**ADDENDUM 002**

**DATE:** August 30, 2019  
**ADDENDUM NUMBER:** 002  
**DG PROJECT NUMBER:** 3050  
**PROJECT NAME:** APS Coyote Willow Family School – Phase 2  
**PROJECT ADDRESS:** 7125 Irving Blvd NW, Albuquerque, NM 87114  
**ISSUED BY:** Wendy E.S. Caruso, AIA, Project Manager

**NOTICE:** *This addendum forms a part of the Contract Documents and modifies the Documents issued by The Hartman + Majewski Design Group and dated September 14, 2018. Acknowledge receipt of this Addendum in locations required on the Pricing Forms. Failure to do so may subject the Proposer to disqualification. All other provisions of the Contract Documents shall remain unchanged. This Addendum contains a total of Thirty One (31) 8 ½" x 11" pages and Six (6) 30" x 42" replacement sheets.*

**S301**

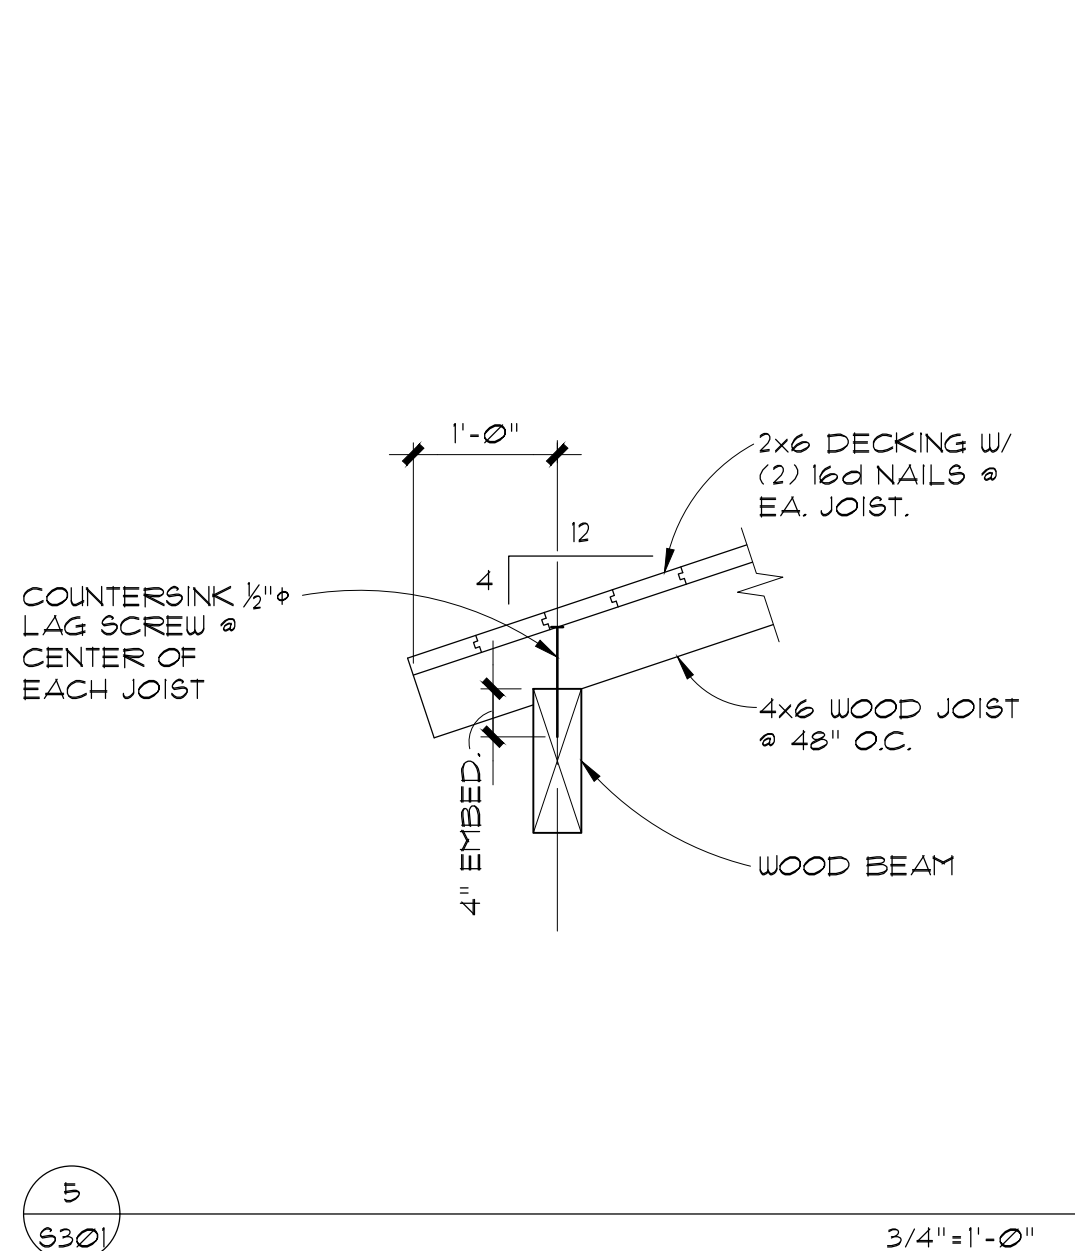
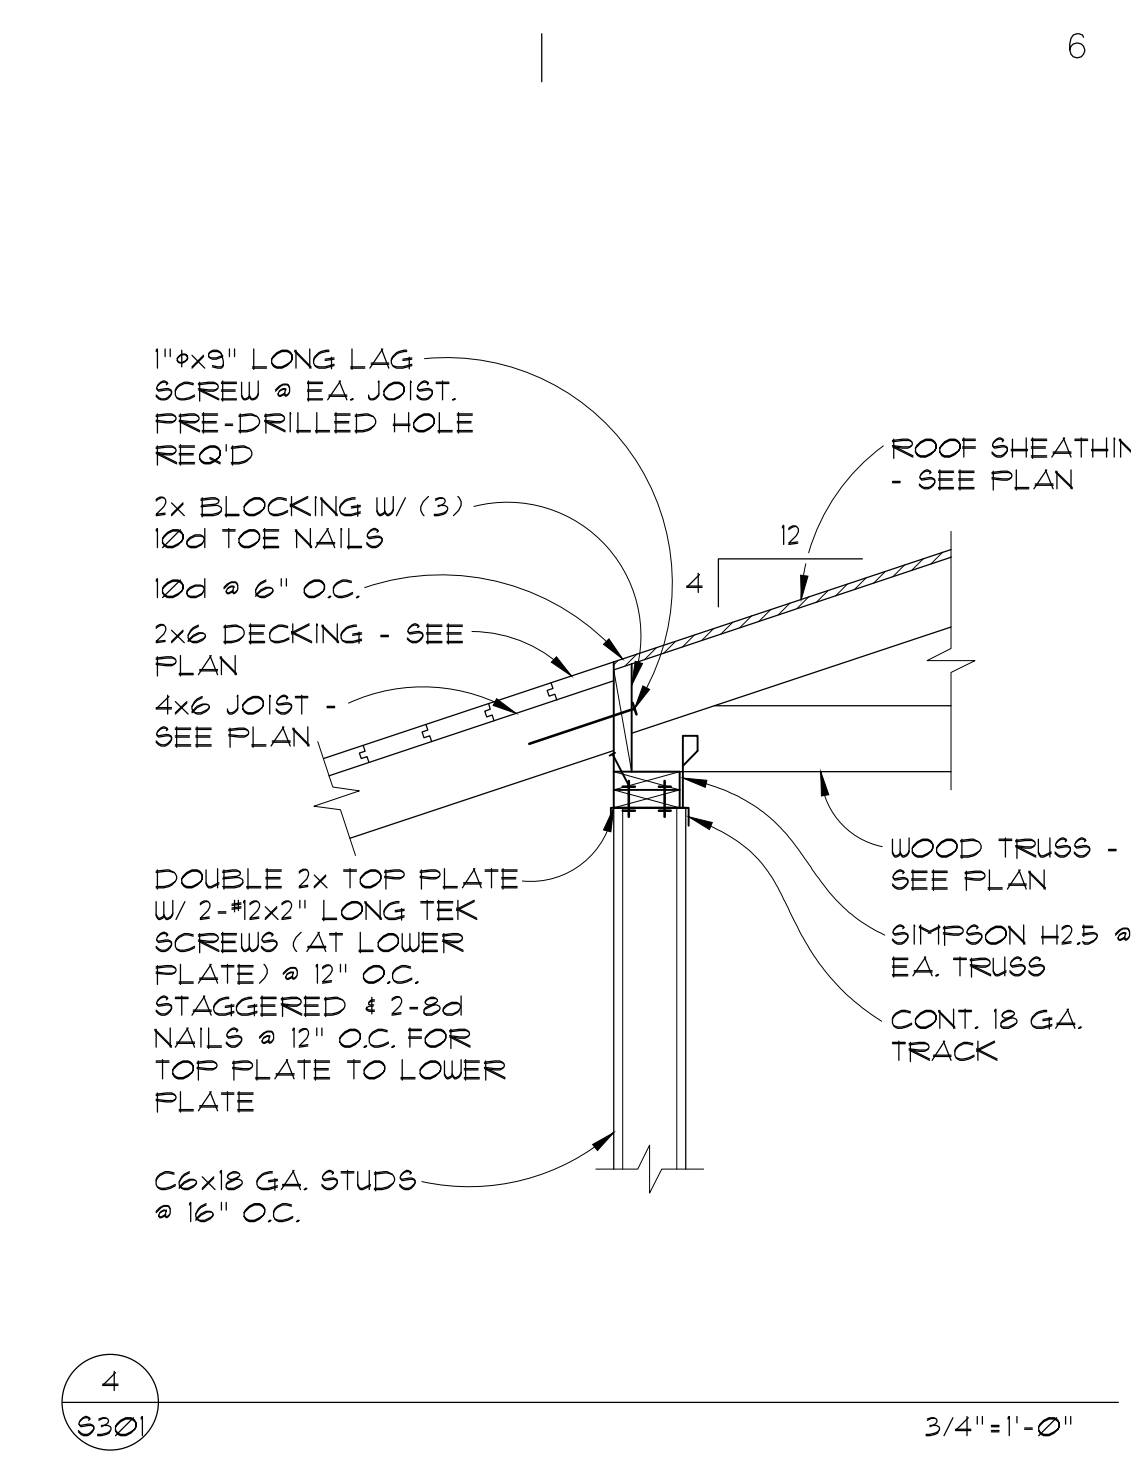
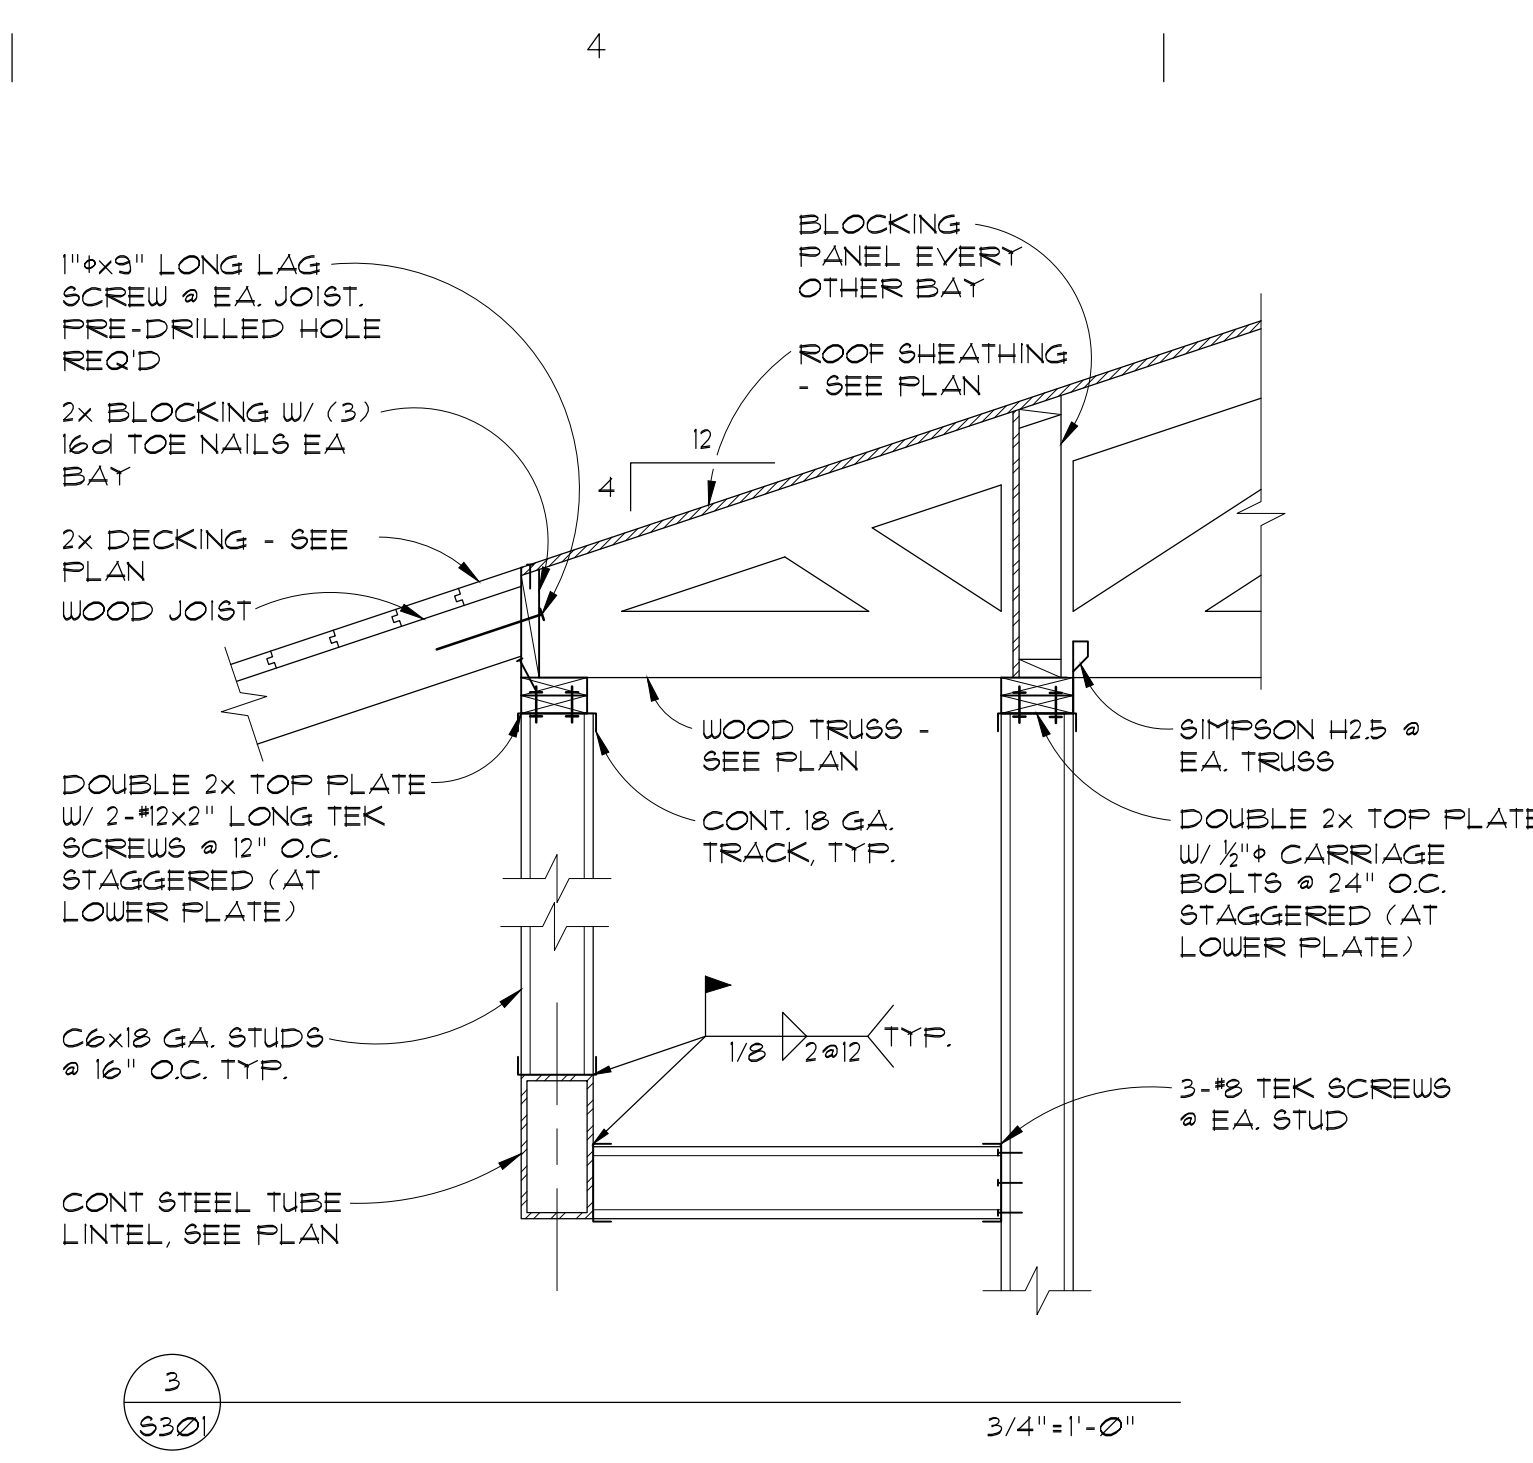
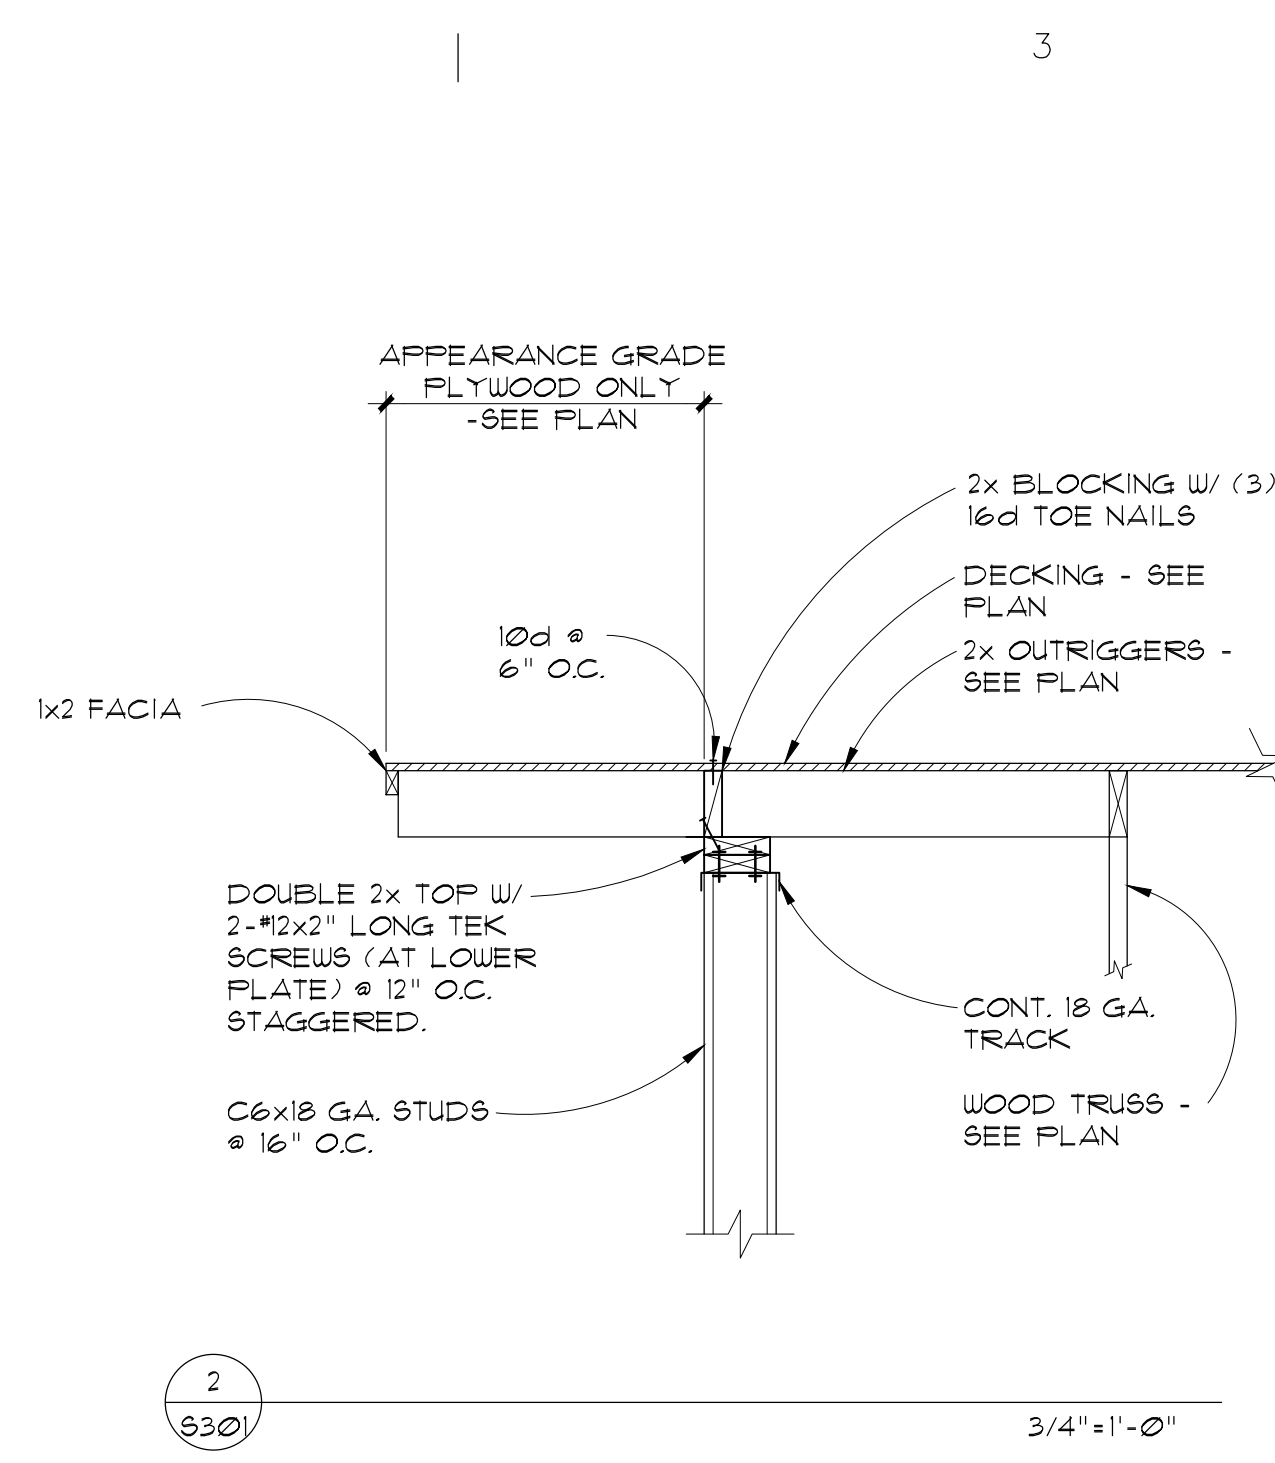
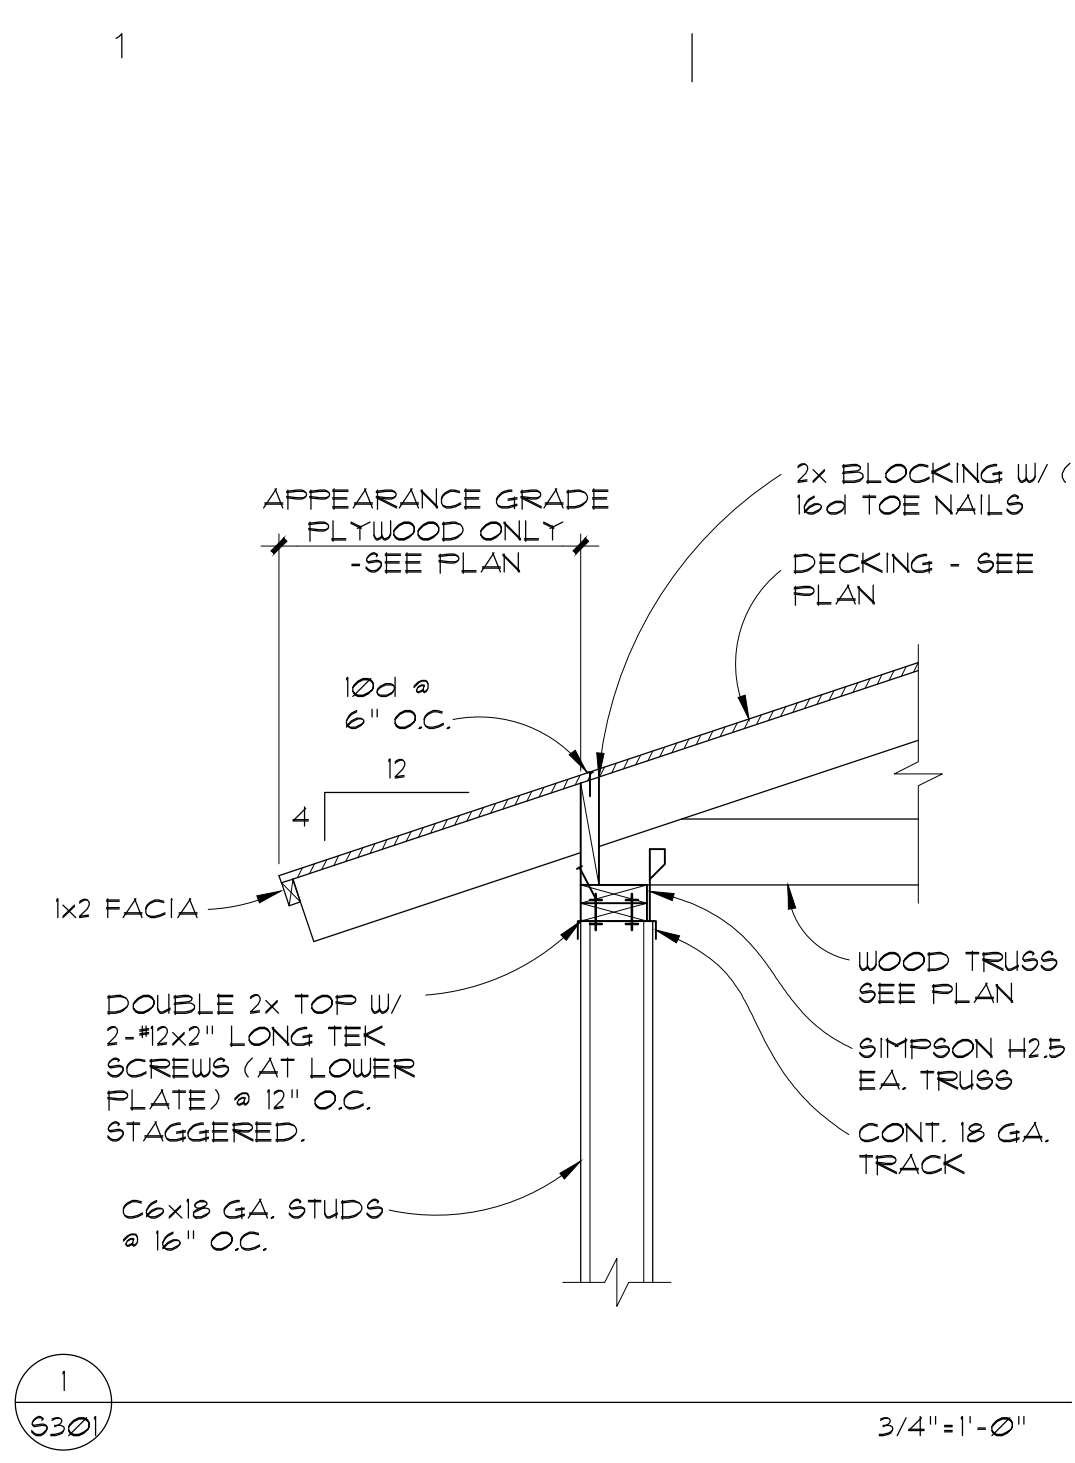
1. Detail 9/S301 has been revised to match the Phase I construction.
2. Detail 11/S301 has been revised to clarify the connection of new roof structure to existing.
3. Detail 15/S301 has been added to describe portal beam support at the inside corner condition.
